| Conservation and Urban Design | |
| Application No: | 22/01221/F & 22/01028/LA |
| Address: | St Christophers School Westbury Park Bristol |
| Description: | Proposed development of the site including, internal and external alterations of Listed House building and conversion of lodges fronting Westbury Park; demolition of buildings and the erection of new buildings to provide an integrated Retirement Community (Class C2) for older people; together with landscaping, car parking, refuse and other associated works (major). |

Figure 2 –

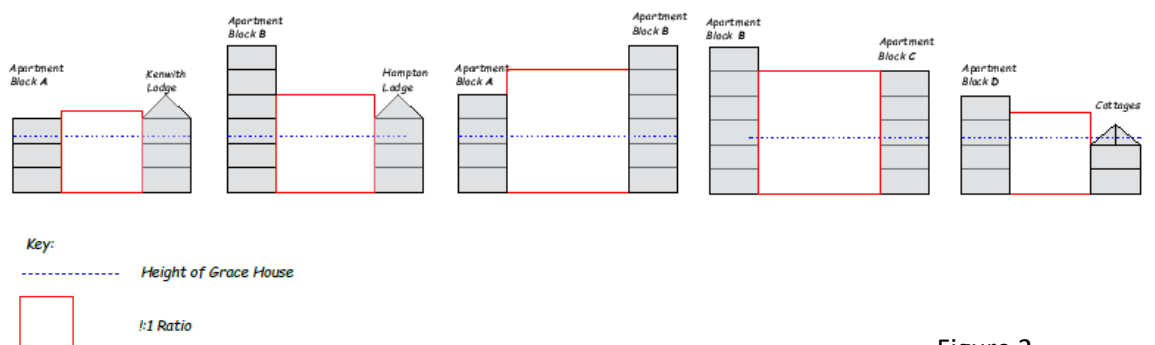
- The relationship between the buildings and the space between the buildings delivers a 1:1 ratio. The National Design Codes and Urban Design Compendium suggest the most extreme enclosure ratio that is acceptable is 1:1.

The enclosure ratio between Apartment Block A,B,C, D, the cottages, Hampton and Kenwith Lodge are broadly 1:1. This ratio would be only be acceptable in the city centre context should all amenity conditions be satisfied but inappropriate to this loose grain verdant back land character area an attribute of the Conservation Area.

Enclosure ratios of the proposals between Apartment Block A, B, C and D.

This ratio will affect how these spaces are experienced with overbearing buildings either side of narrow, overshadowed areas of public realm which will impact tree growth due to lack of light. The shadow analysis within the D&A Statement show these spaces will be overshadowed for most of the year.
